HARTZELL PROPELLER INC.

ALERT SERVICE BULLETIN

HC-ASB-61-405

109438 Beta Rod Support Ring

Beta System Component Installation
Figure 6

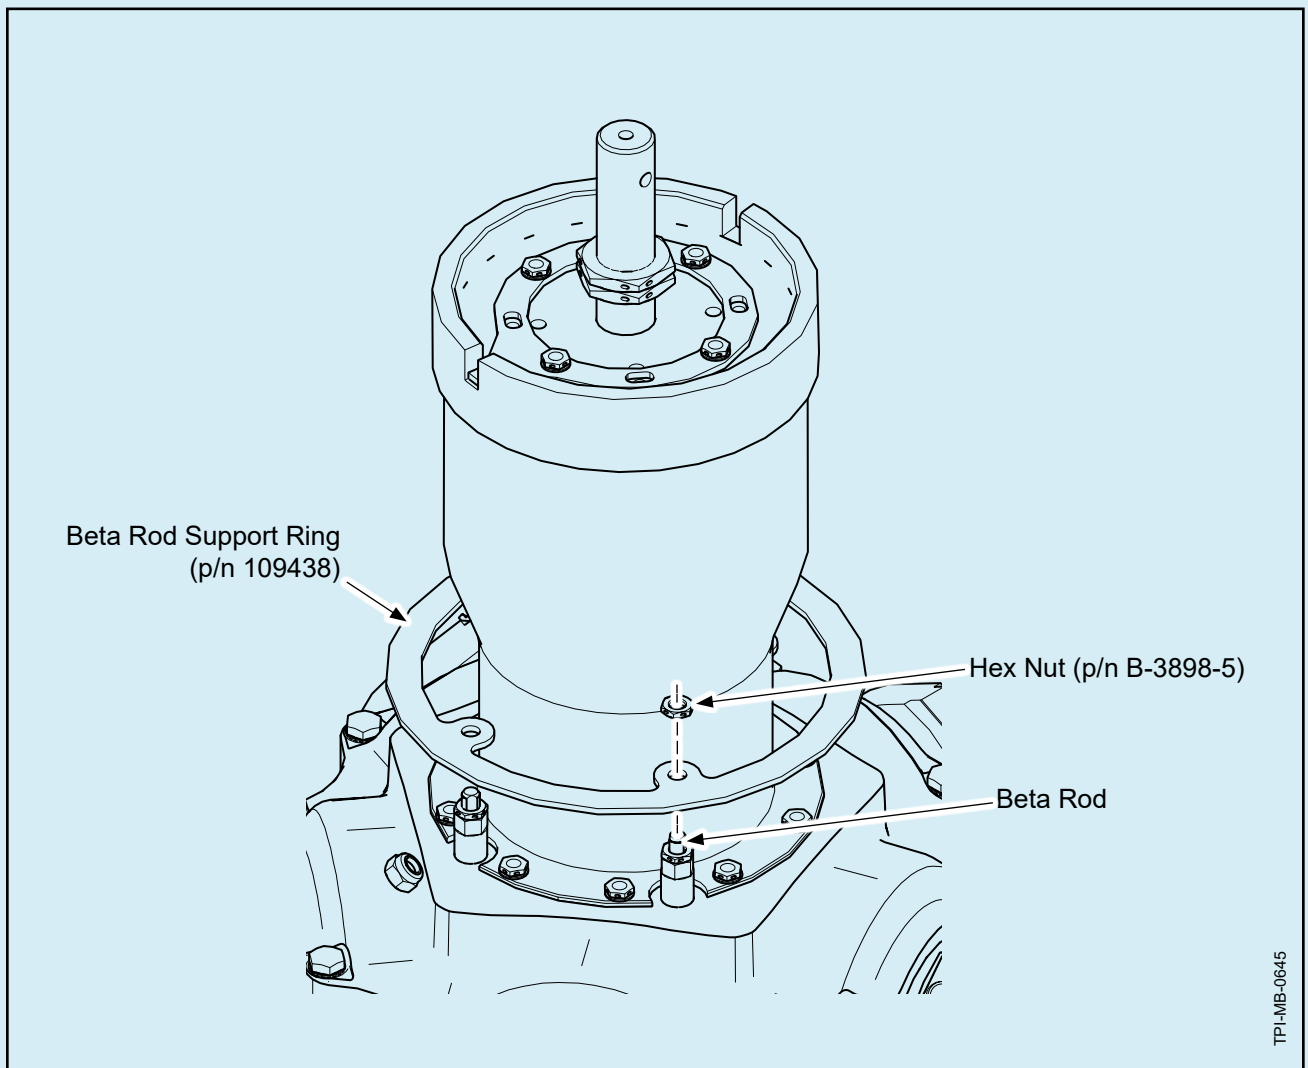
- (7) Install the beta system components in accordance with Figure 6 and the following steps:
- (a) Apply a light coat of NYCO grease CM12 to the three beta sleeves (p/n B-457).
 - (b) Lift and rotate the beta rod support ring (p/n 109438), then install three beta sleeves (p/n B-457) and beta rods (p/n 107372) thru the hub unit.
 - (c) Install a spring guide sleeve (p/n A-466-1, Rev. I or later), compression spring (p/n 109235), spring guide (p/n 107373-2), and hex nut (p/n B-3898-5) onto the engine-side of each beta rod.
 - 1 Optionally, use the spring installation tool TE658 to compress the compression spring (p/n 109235) when installing the hex nuts (p/n B-3898-5). Refer to the section, "Using the Spring Installation Tool" Hartzell Propeller Inc. Raptor Series Turbine Propeller Overhaul Manual 496 (61-10-96).

- (d) Install the beta ring (p/n 108272) on the engine-side of the beta rods.
 - 1 Using a 1/4 inch open-end wrench on the flats on the cylinder-end of the beta rods (p/n 107372), turn the beta rods into the beta ring (p/n 108272).

**Beta Rod Support Ring Installation
Figure 7**

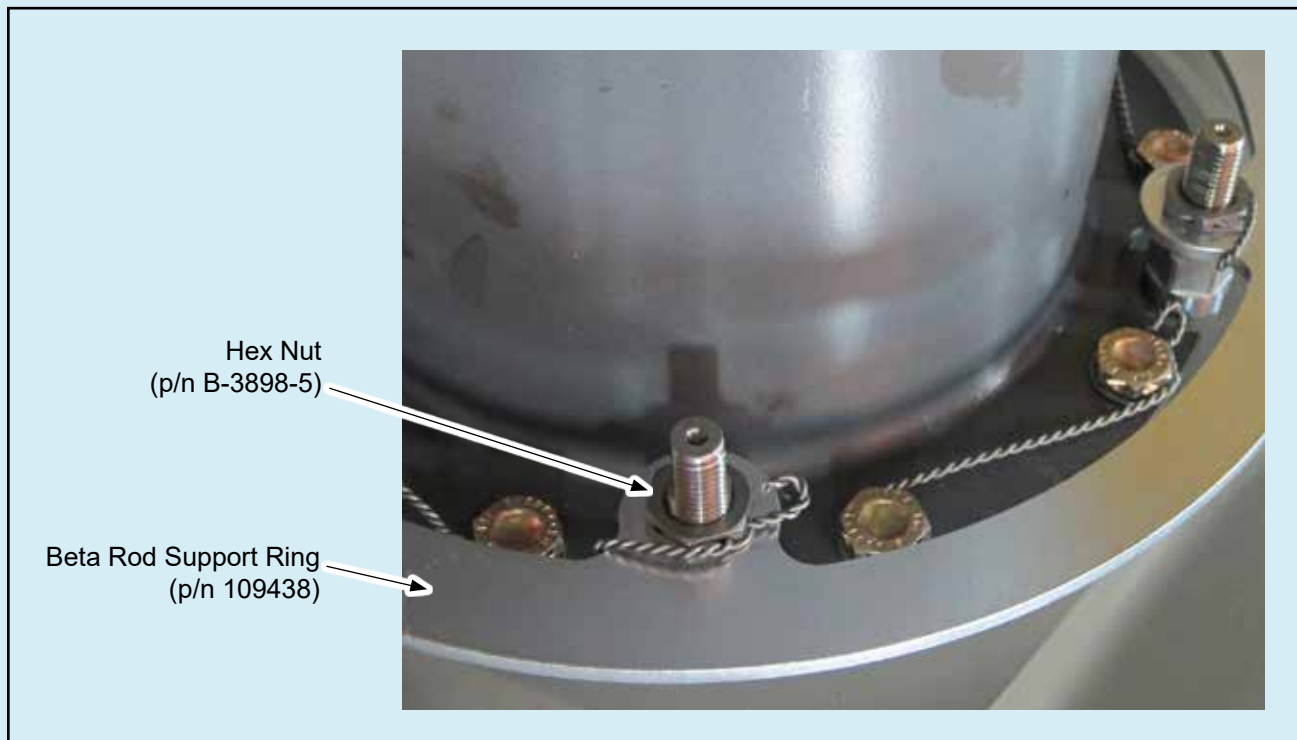
- (10) Install the beta rod support ring (p/n 109438) in accordance with Figure 7 and the following steps:
- (a) Install the beta rod support ring (p/n 109438) on the three beta rods.
 - (b) Install three hex nuts (p/n B-3898-5) onto the beta rods.
 - 1 Torque the hex nuts (p/n B-3898-5) to 108-132 In-Lbs (13-14 N•m).
